Subject: Prospect #3 – ORFM System Improvements
Minor Project Modification
IOAP Project No. S_OR_MF_NB04_M_03_B_B
DOJ Case No. 90-5-1-1-08254

MSD is requesting approval of a proposed minor project modification to the Prospect #3 – ORFM System Improvements project (IOAP Project No. S_OR_MF_NB04_M_03_B_B). This modification is part of an overall adaptive management review of the approved 2012 IOAP Modification.

Prospect #3 - ORFM System Improvements

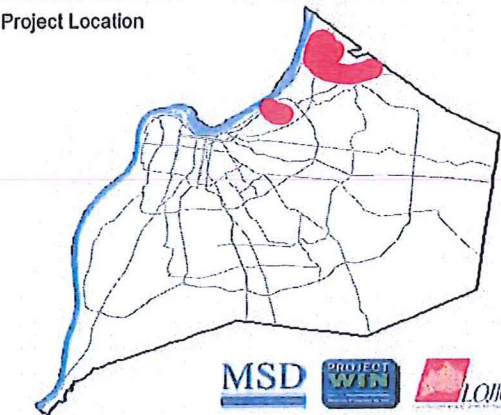
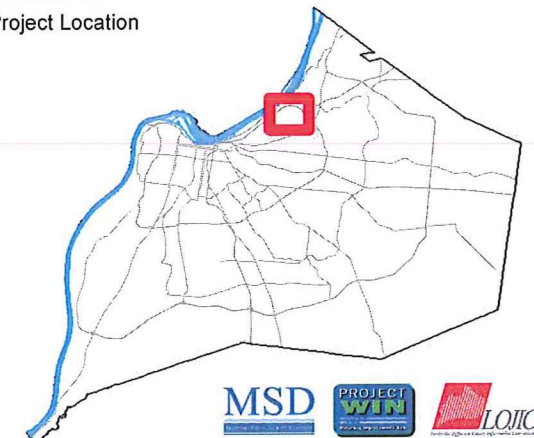
The project modification proposed constructs a 1.96 million gallon (MG) covered off-line storage basin at the location of the upper-most SSO on the Muddy Fork Interceptor. This provides the same function as the originally proposed in-line storage, without the disruption caused by removing and replacing an existing 8,350 LF of interceptor through several established subdivisions. The three pump stations will be upgraded and the discharge of the Muddy Fork Pump Station will be upsized in accordance with the original project concept. No change in project schedule is proposed.

The proposed project modification provides the same wet weather capacity storage volume as the original project scope. The only difference is that storage is provided in an off-line basin rather than through in-line storage. Additionally, hydraulic modeling demonstrates that the level of control remains the same, at a 2.25-inch 3-hour cloudburst rain event. MSD prefers to construct a project on a single site rather than disrupting a much larger and densely populated area while replacing an active gravity pipe.

Modeled Area ORFM
Branch or SSO ID NB04
Project Type Pump Station Upgrades & Storage
Receiving Stream Goose Creek, Ohio River
Project Description Construct a 1.96 MG covered storage basin. Upgrade pumps at Muddy Fork, Winding Falls/Phoenix Hill PS and New Market PS. Upsize force main from Muddy Fork PS to 24".
Reason for Overflow ORFM and pump station capacity
Design Parameters This solution is based on a 2.25 inch cloudburst rain event.
Project Constraints N/A
Estimated Capital Cost \$4,500,000
Weighted Benefit/Cost Rati 4.8
